**COLORADO DIVISION OF RECLAMATION, MINING AND SAFETY**  
**MINERALS PROGRAM INSPECTION REPORT**  
**PHONE: (303) 866-3567**

<b>MINE NAME:</b> Amzak Pit	<b>MINE/PROSPECTING ID#:</b> M-2003-003	<b>MINERAL:</b> Gravel and sand	<b>COUNTY:</b> La Plata
<b>INSPECTION TYPE:</b> Monitoring	<b>INSPECTOR(S):</b> Kate A. Pickford	<b>INSP. DATE:</b> September 19, 2013	<b>INSP. TIME:</b> 12:00
<b>OPERATOR:</b> Consolidated Constructors, Inc.	<b>OPERATOR REPRESENTATIVE:</b>	<b>TYPE OF OPERATION:</b> 112c - Construction Regular Operation	
<b>REASON FOR INSPECTION:</b> Normal I&E Program	<b>BOND CALCULATION TYPE:</b> Complete Bond	<b>BOND AMOUNT:</b> \$118,787.00	
<b>DATE OF COMPLAINT:</b> NA	<b>POST INSP. CONTACTS:</b> None	<b>JOINT INSP. AGENCY:</b> None	
<b>WEATHER:</b> Clear	<b>INSPECTOR'S SIGNATURE:</b> 	<b>SIGNATURE DATE:</b> October 9, 2013

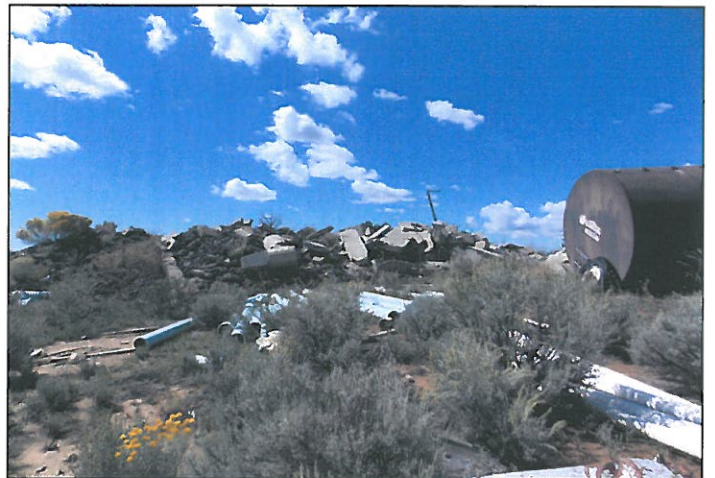
**PROBLEM/POSSIBLE VIOLATION:** Problem: There are state-listed noxious weeds present on site. This is a problem for failure to employ weed control methods for state listed noxious weed species within the permitted area, and to reduce the spread of weeds to nearby areas as required by Section 3.1.10 (6) of the rule.

The upper area contains a large amount of Knapweed. This is considered a noxious weed and must be controlled under a weed control plan. See the problem cited in the problem section of this report. There is topsoil stockpiled in the upper area, as well as various material stockpiles. It appears that there is adequate topsoil present for reclamation of the site.

**CORRECTIVE ACTIONS:** Implement approved weed control plan and provide proof to the Division that this has been done. Please supply proof that the Knapweed has been sprayed or removed by the resolution date listed.  
**CORRECTIVE ACTION DUE DATE:** 11/11/13
